# Sumter City-County Planning Commission

November 19, 2025

## SD-25-04, 1991 Stamey Livestock Rd. – Shenandoah at The Village (City)

**Figure 2 - Shenandoah at The Village Area Plan**

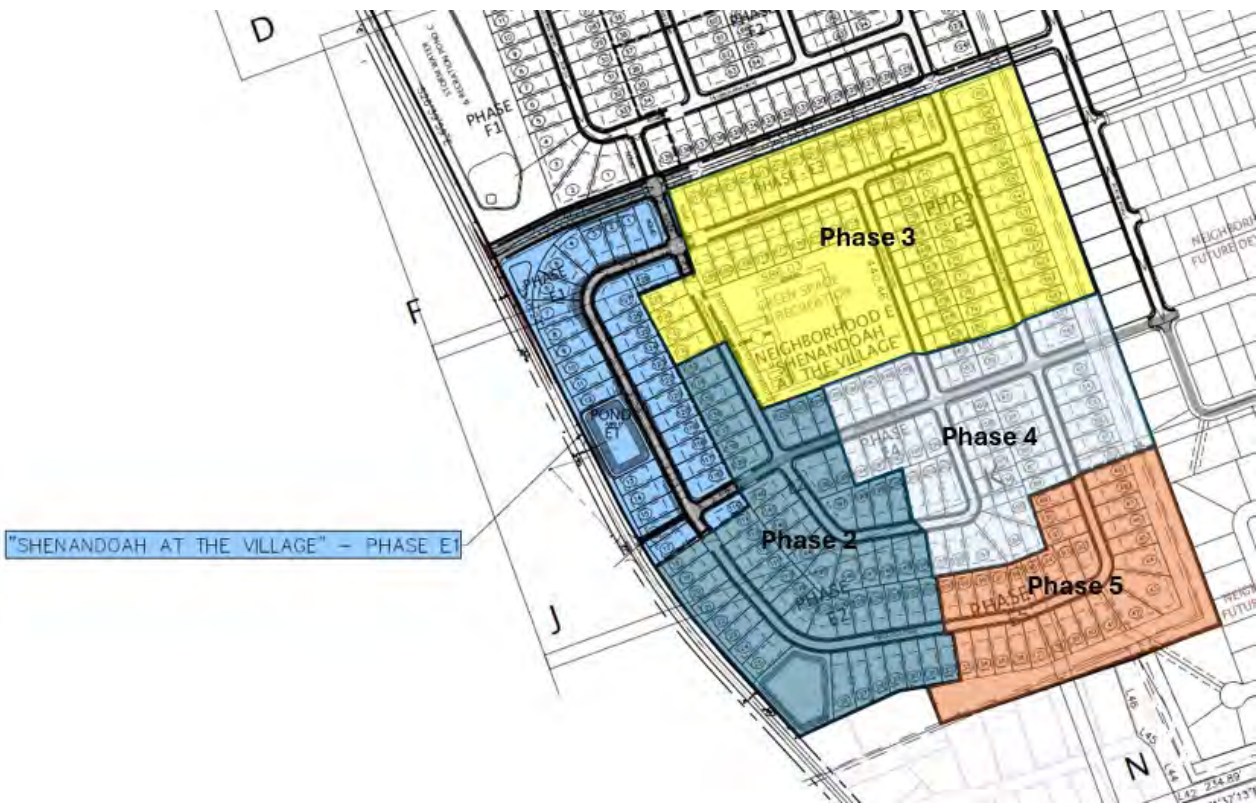
The lot count for Shenandoah at The Village (“Neighborhood E”) as specified in the approved General Development Plan is 220. The submitted lot count is 217, which is below the approved total by 3 lots. The Planning Commission may approve the subdivision at the lot/unit count proposed, with the 3 lots deducted from the neighborhood available to offset increased lot count in other neighborhood(s) in the development to maintain the maximum unit count of 991 for the entire GDP.

The proposed preliminary plan indicates that proposed single family detached lots range from 9,000 sq. ft. to 23,508 sq. ft. in size. Lot widths for all single-family detached lots as shown on the plan have a width of least 60 ft.

Above: Subdivision Layout Graphic with Phasing

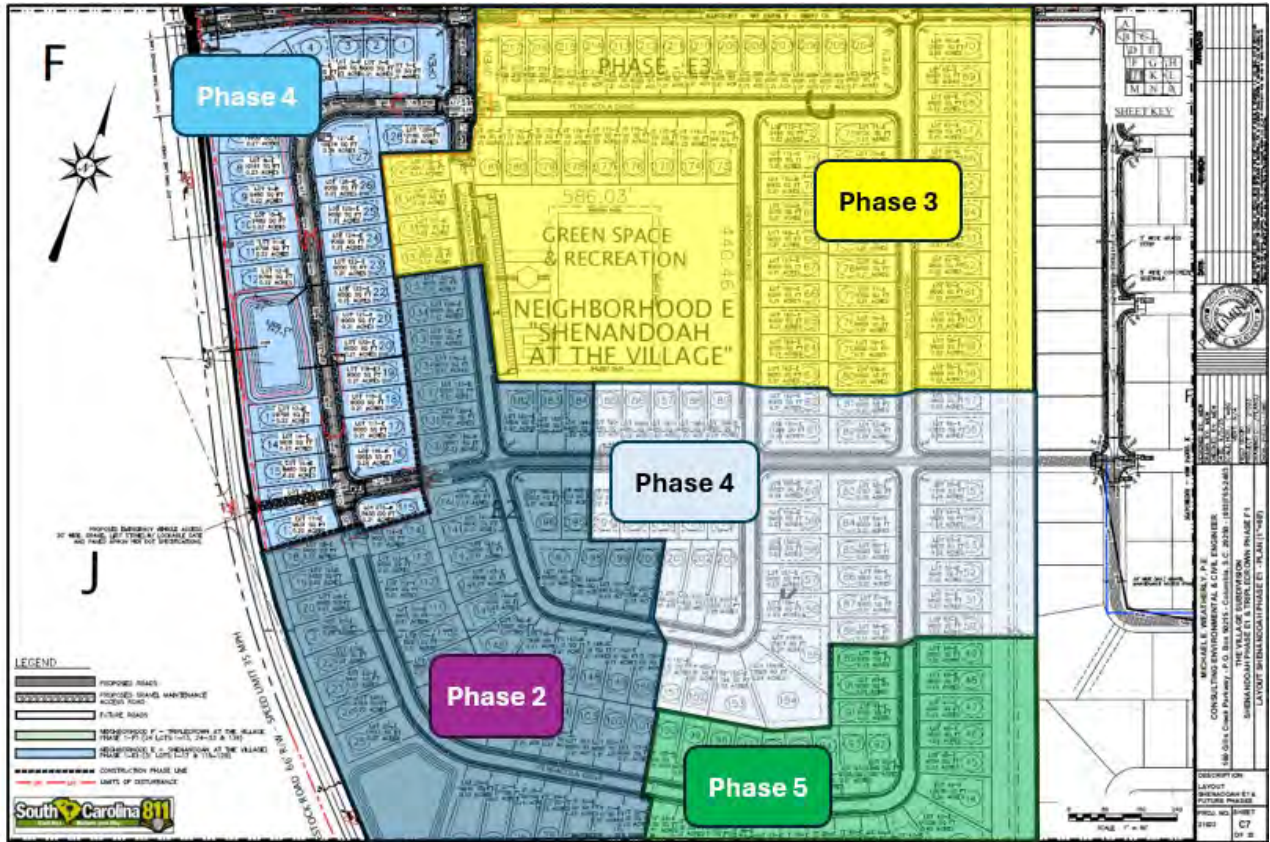
The Shenandoah at The Village subdivision is proposed to be developed in 5 phases. Phase 1 consists of 31 lots on a portion of Pensacola Dr. Phase 2 consists of 56 lots on portions of Pensacola Dr., and Shenandoah Dr., and Apalachicola Dr., Phase 3 consists of 60 lots on portions of Pensacola Dr. and Shenandoah Dr., Phase 4 consists of 41 lots on portions of Shenandoah Dr., Pensacola Dr., and Apalachicola Dr., and Phase 5 consists of 29 lots on a portion of Pensacola Dr.

A staff recommended condition of approval is that prior to final plat approval for any lots in Phase 4 and/or 5, the future Main Entrance Road B as indicated on the GDP be installed to provide secondary access to the subdivision. Further, the secondary emergency access may only be removed after construction of Main Entrance Road B and connection via Silvercharm Dr.

Figure 3 - Shenandoah at The Village, Phase 1 Landscaping Plan and Planting Schedule

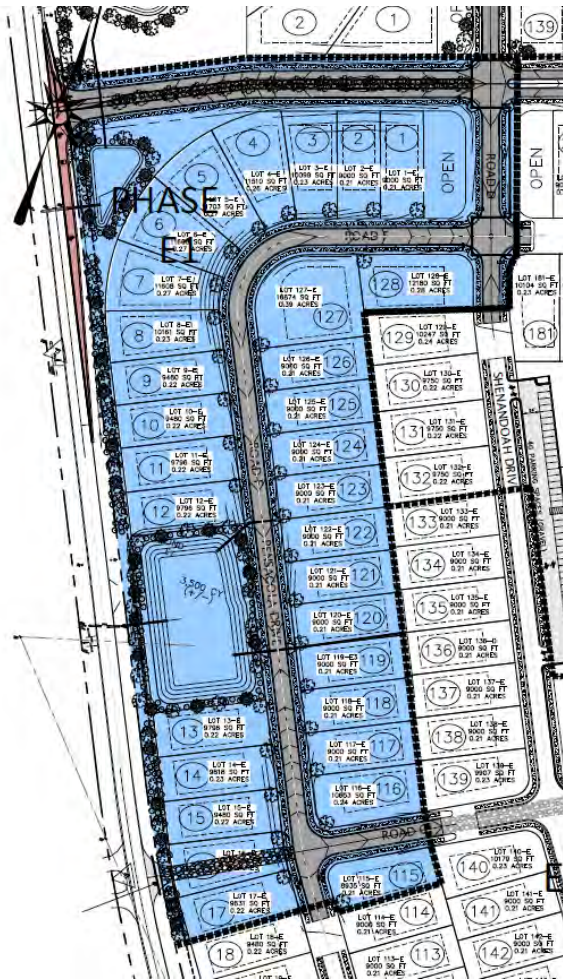
The existing site for the proposed Shenandoah at The Village subdivision is primarily open, with no significant or historic trees present. Street and stormwater landscape buffer areas have been identified on submitted plans. However, detailed landscaping plans for phases 2-5 have not been submitted at this time. Submission and staff approval of these plans is required prior to final plat approval for each subsequent phase.

1 street canopy tree, 2 inch caliper and 7 ft. in height, is required for each unit/lot. Dwellings must also have sodded front yards. These items must be complete prior to certificate of occupancy issuance for each unit/lot. Additionally, grading and sodding of the identified community mailbox area (at least 15 ft back from edge of pavement) is included as a proposed condition of approval.

THE VILLAGE SUBDIVISION  
SHENANDOAH PHASE E1 & TRIPLECROWN PHASE F1  
LAYOUT SHENANDOAH PHASE E1 - PLAN (1"=80')

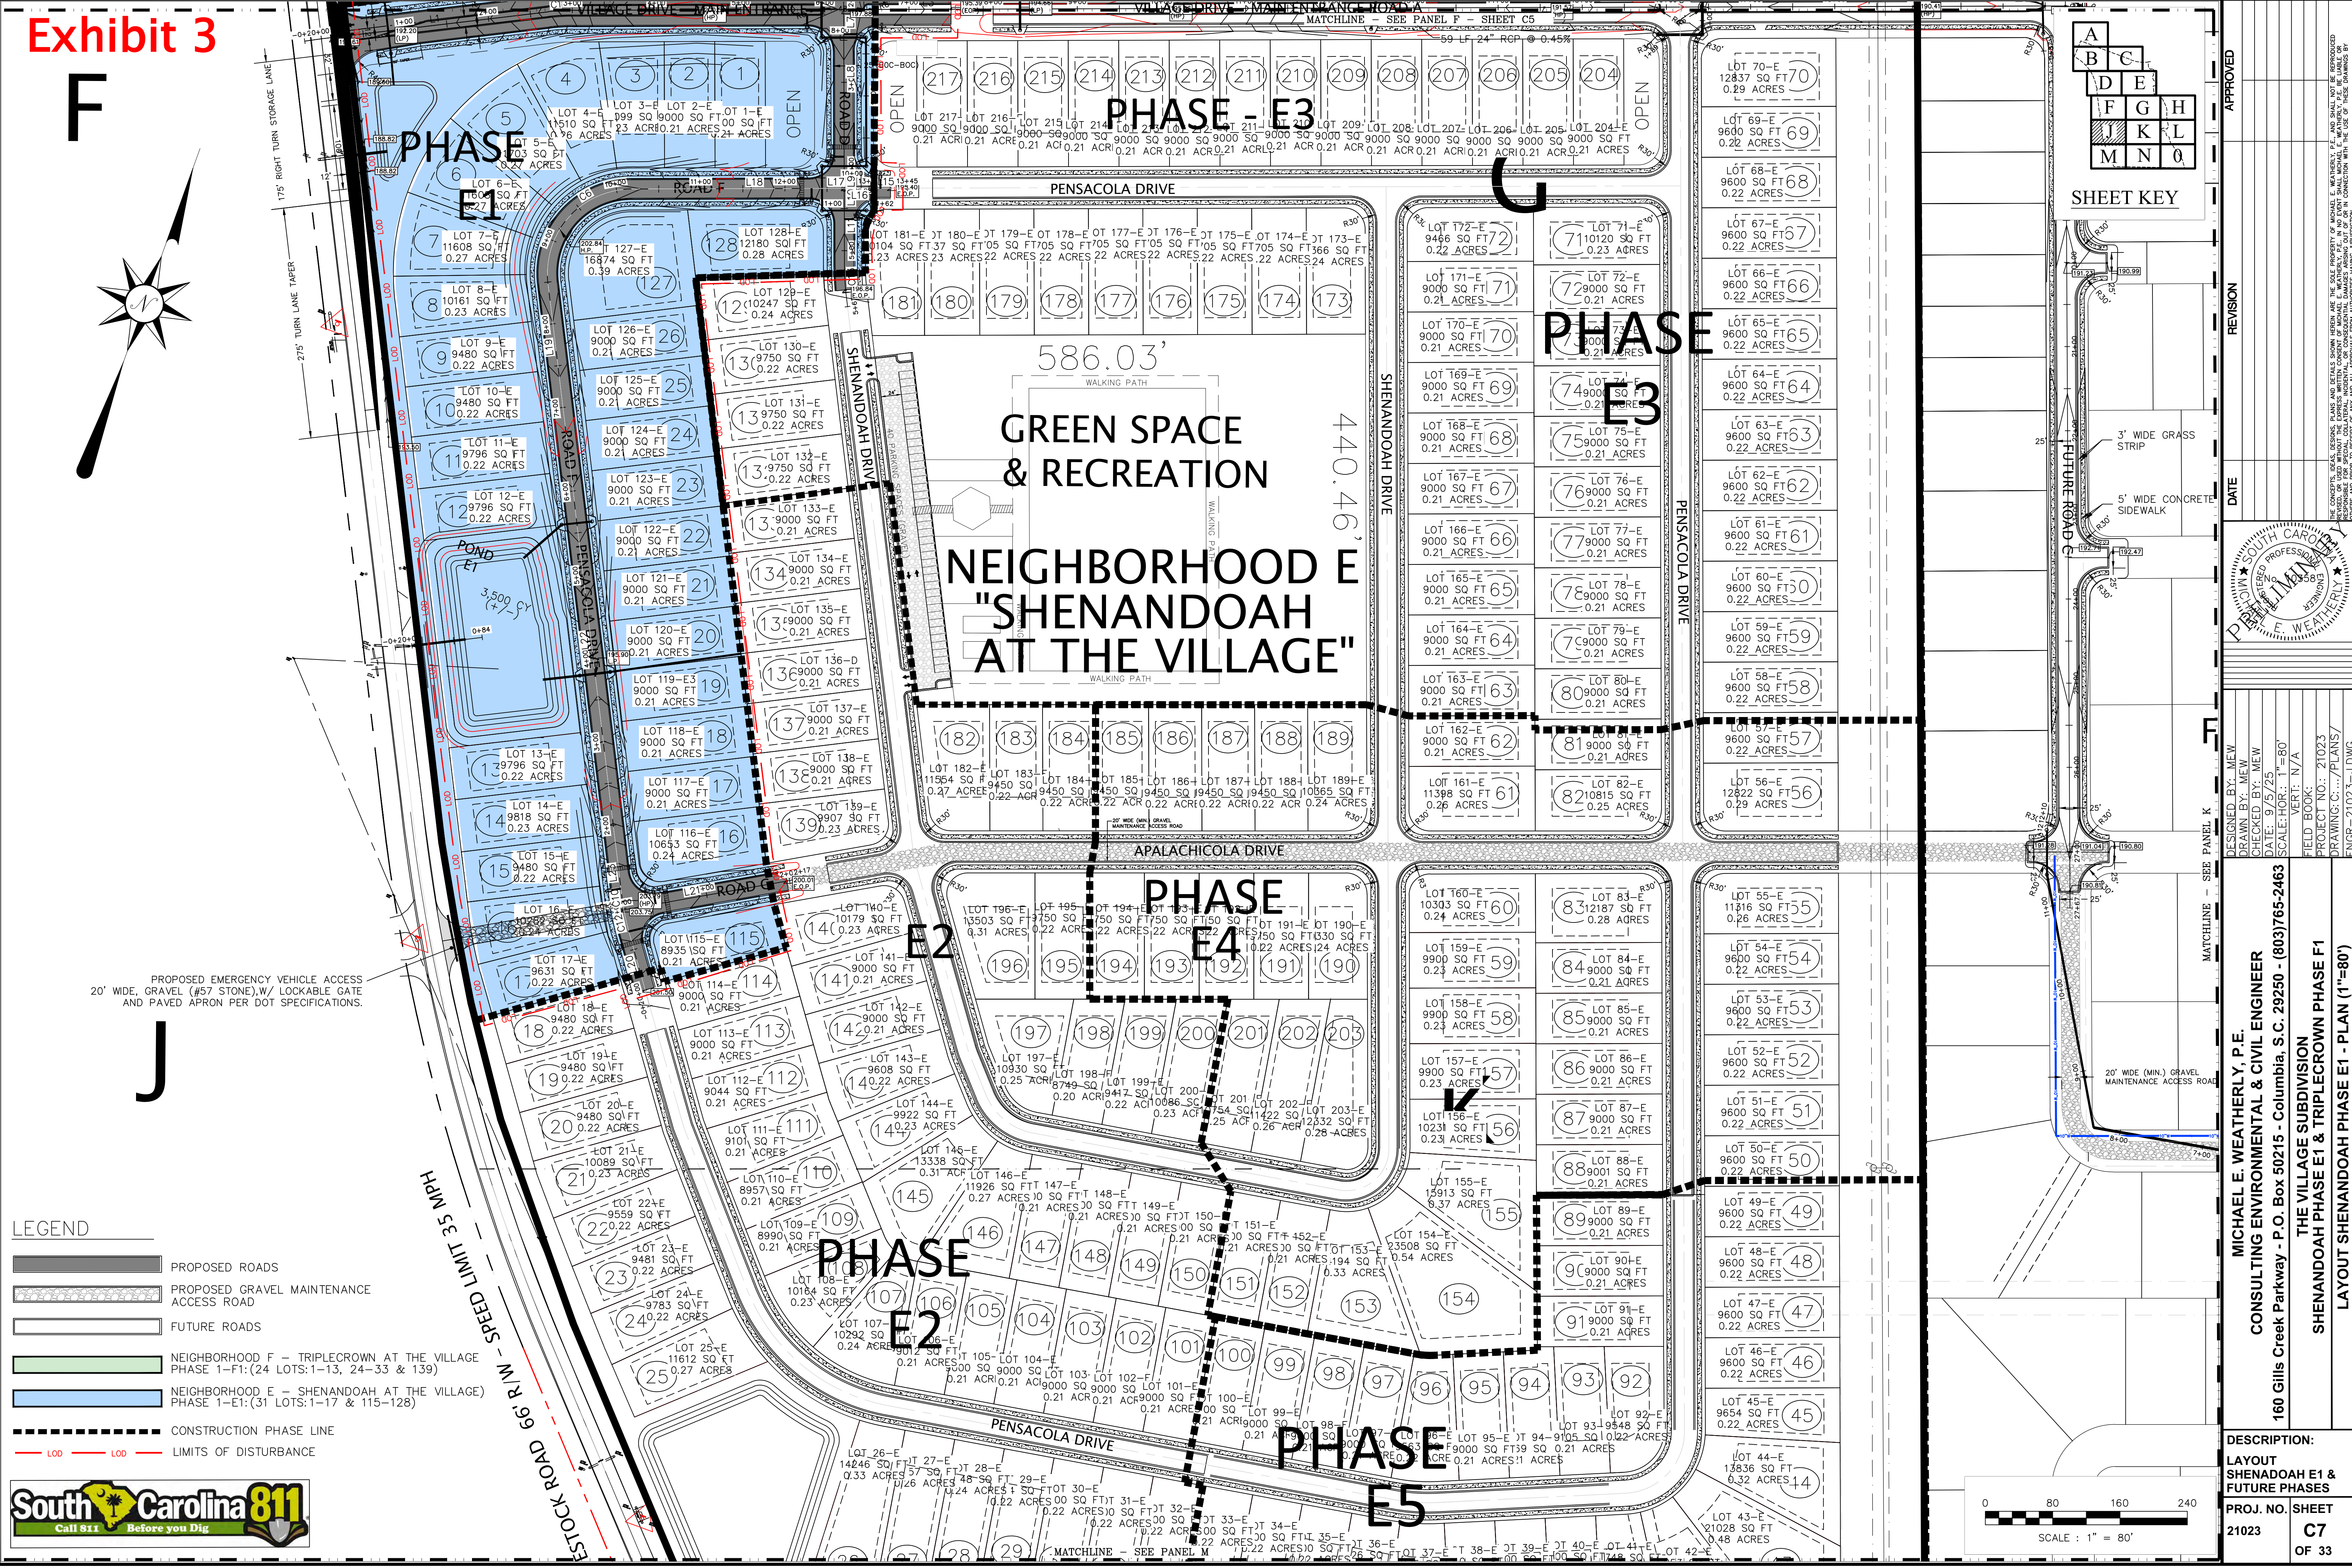
1. Submission of stormwater pond details, including total facility size for proposed pond.
2. Provide copy of SCDOT encroachment plans detailing all proposed work within Stamey Livestock Rd. right-of-way.
